## **ADDENDUM NO. 2**

Date: May 23, 2018

**Project: Hiram Johnson HVAC Replacement**

Sheet  
**A6.11**  
Sheet 2 of 200

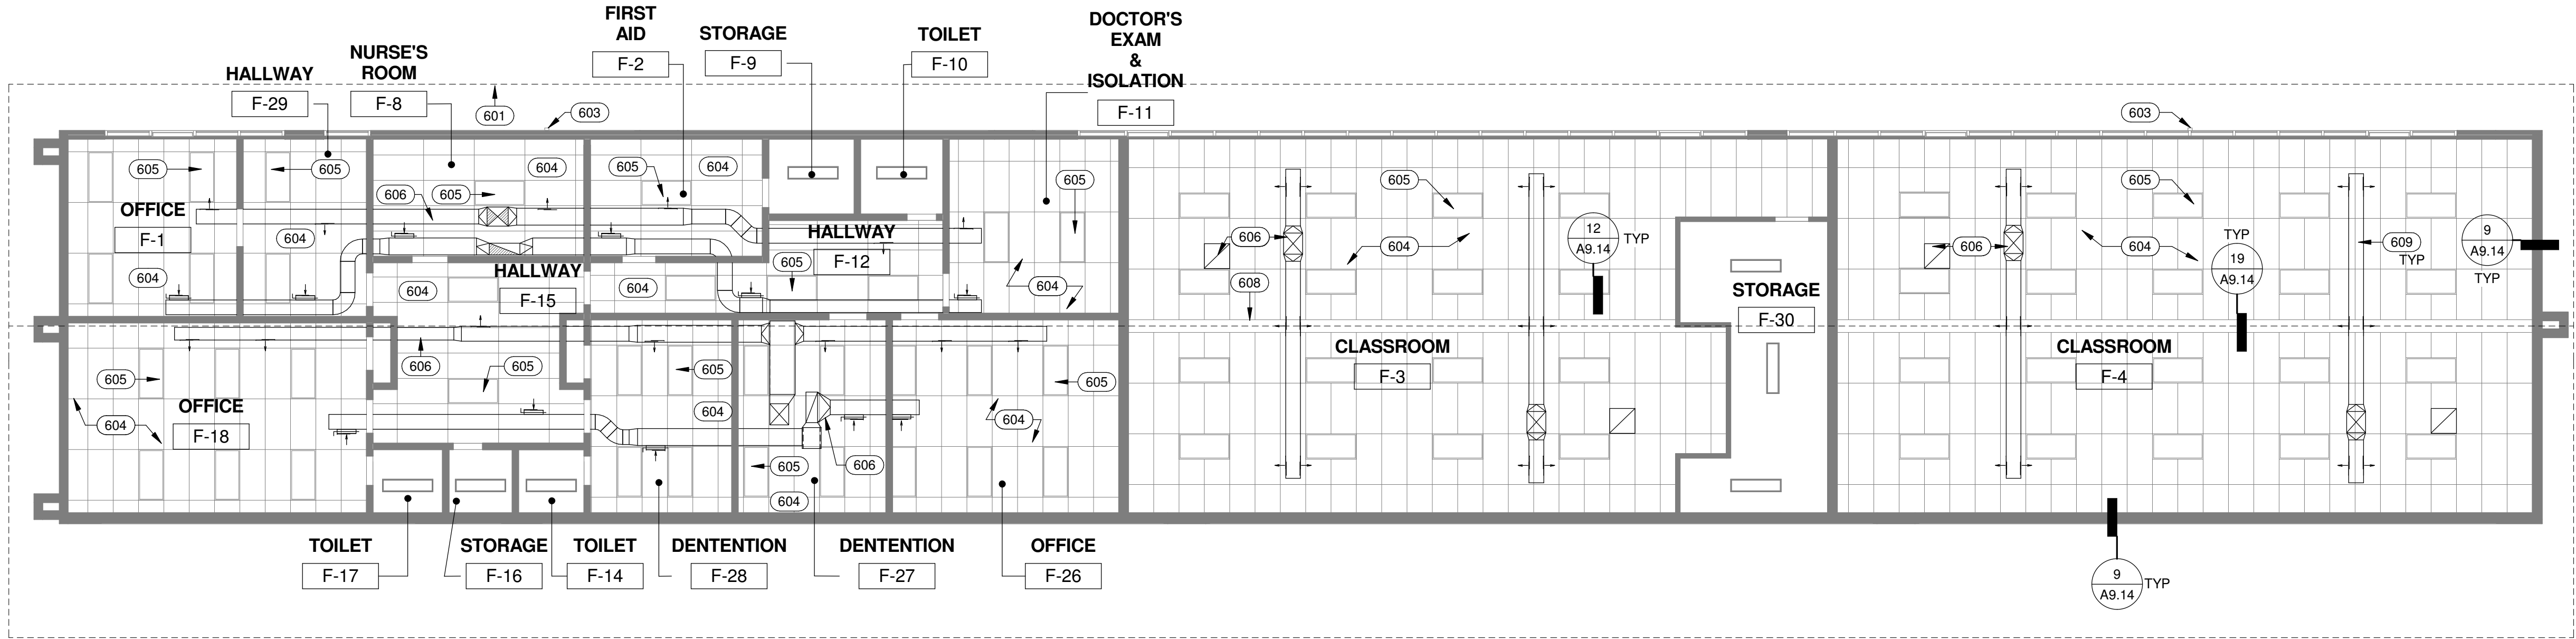
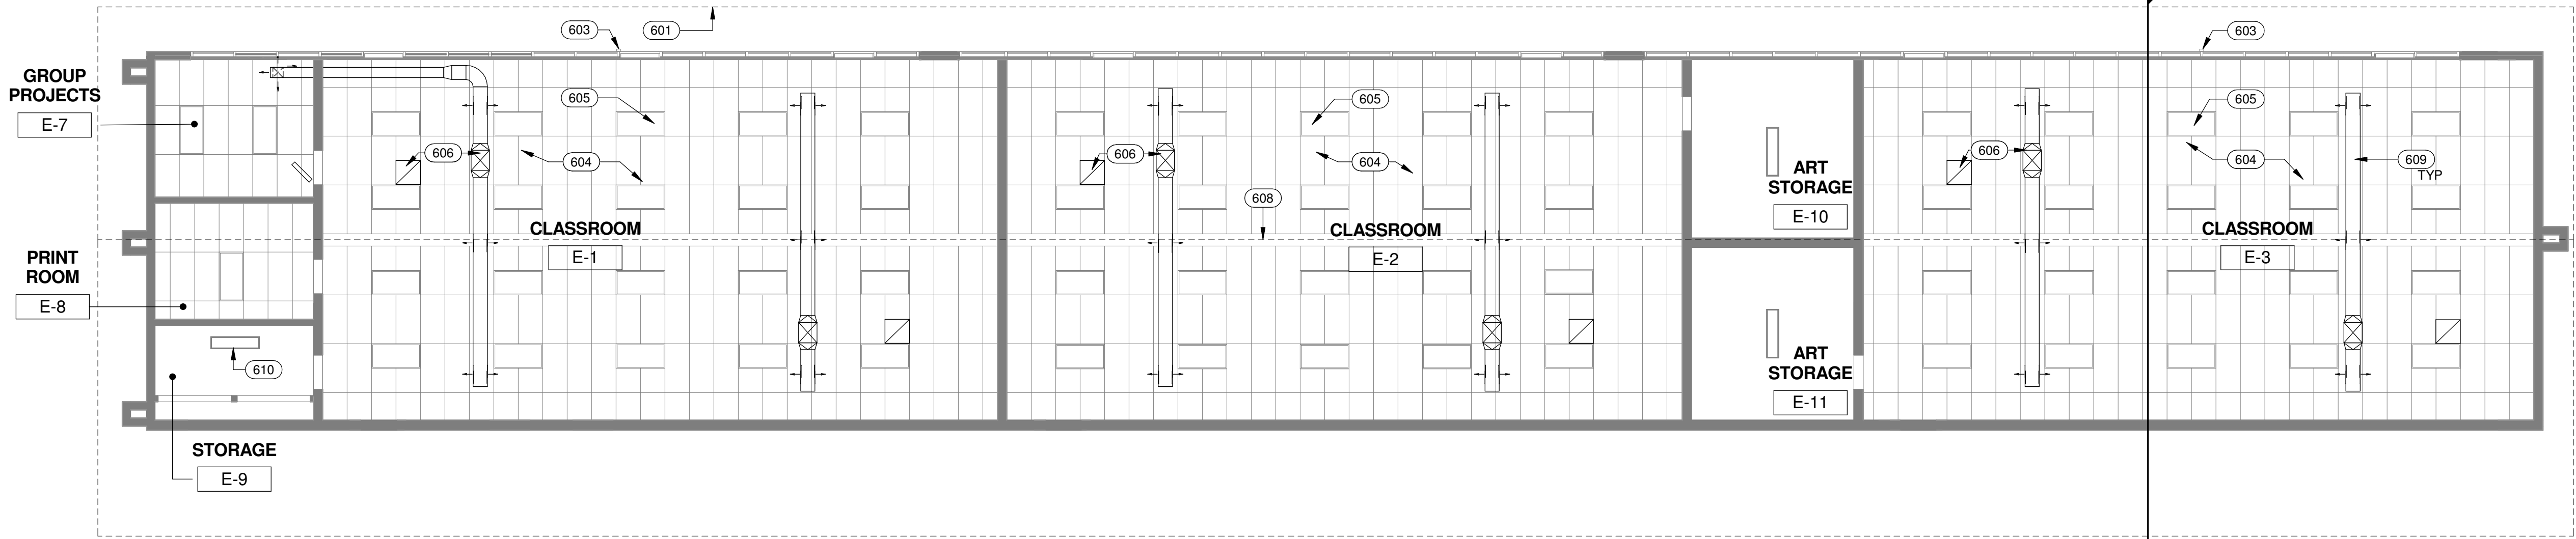
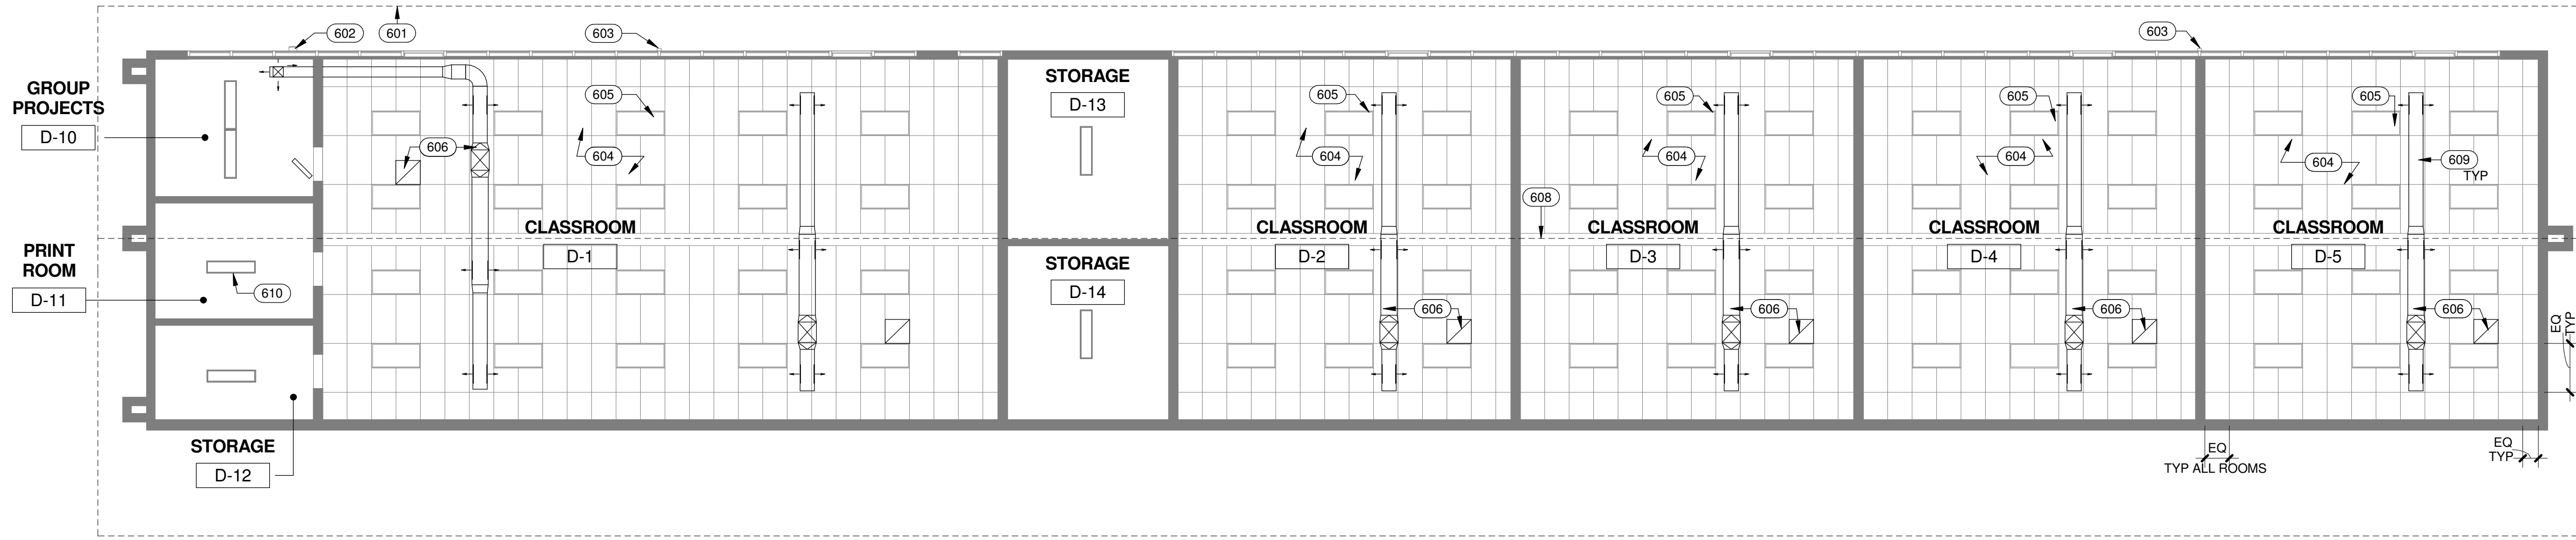
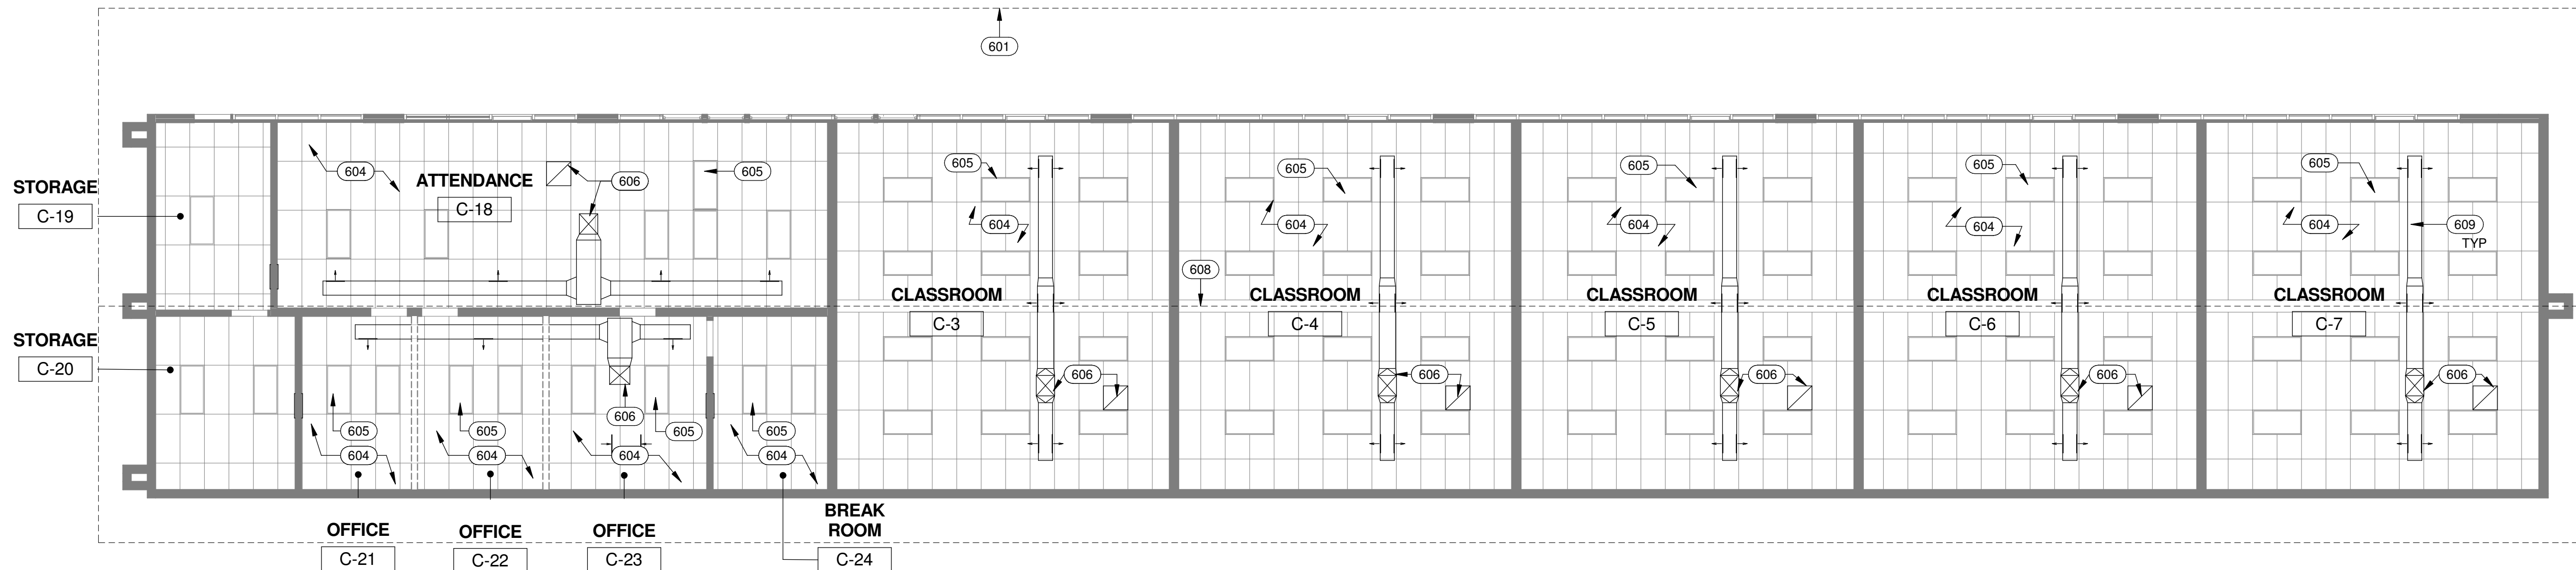
**Refer to Drawing Sheet A6.11 & A6.12**

**Note:** Clouded areas clarify ceiling tile grid at 24" x 48"

Sheet  
1 of 200  
**M0.03**

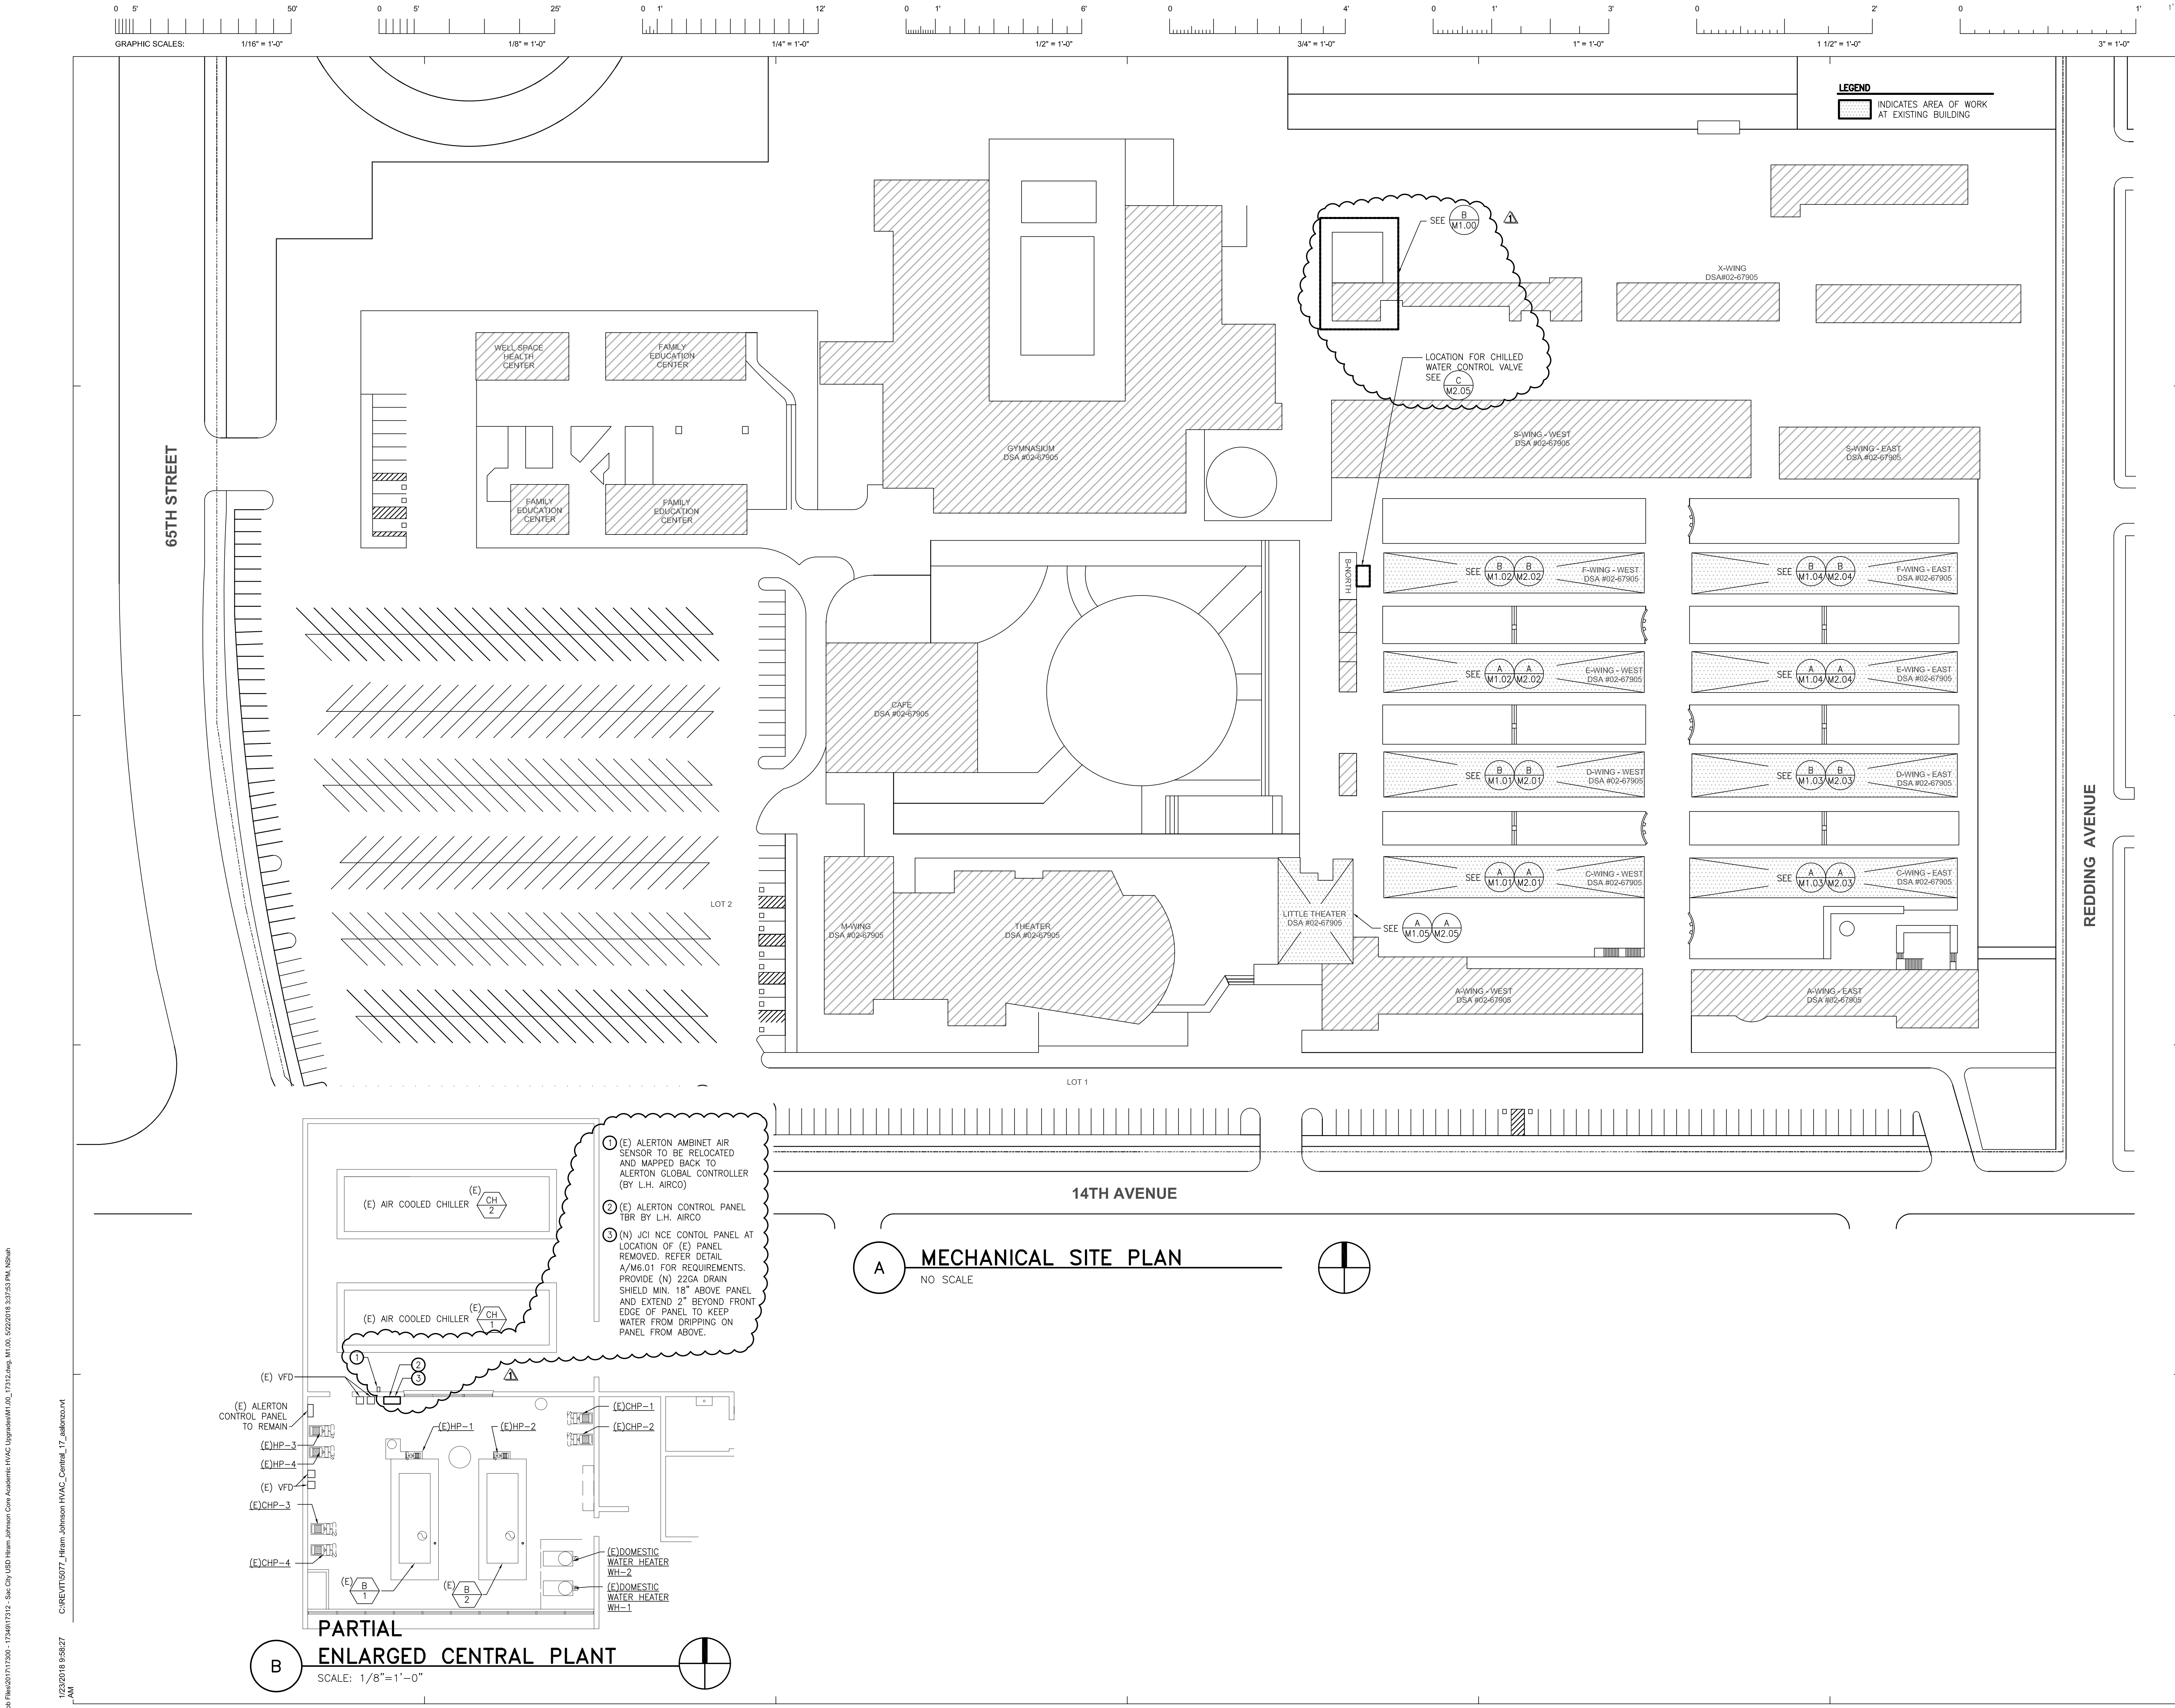
**Refer to Drawing Sheet M0.02 and M0.03**

**Note:** Revised the notes under packaged roof top AC unit schedule to update the spring roof curb, pressure transducer for power exhaust and 4 inch thick filter requirements

- 1) PROVIDE ROOF CURB W/ SPRING ISOLATOR & SEISMIC CLIPS FOR UNIT ATTACHMENT (SEE A/M5.02 FOR CURB & CLIP QUANTITY)
  - 2) PROVIDE COMPLETE ECONOMIZER WITH MICROMETL PCD-FLHA-4V MODULATING POWER EXHAUST (W/VFD). POWER EXHAUST SHALL BE POWERED SEPARATELY FROM UNIT.  
MFR OF UNIT WILL PROVIDE THE PRESSURE TRANSDUCER FOR CONTROLLING POWER EXHAUST VFD. WHERE TWO UNIT SERVES ONE CLASSROOM (I.E. UNIT WITH A & B DESIGNATION) ONLY PROVIDE ONE PRESSURE TRANSDUCER FOR CONTROLLING BOTH UNITS POWER EXHAUST VFD IS REQUIRED
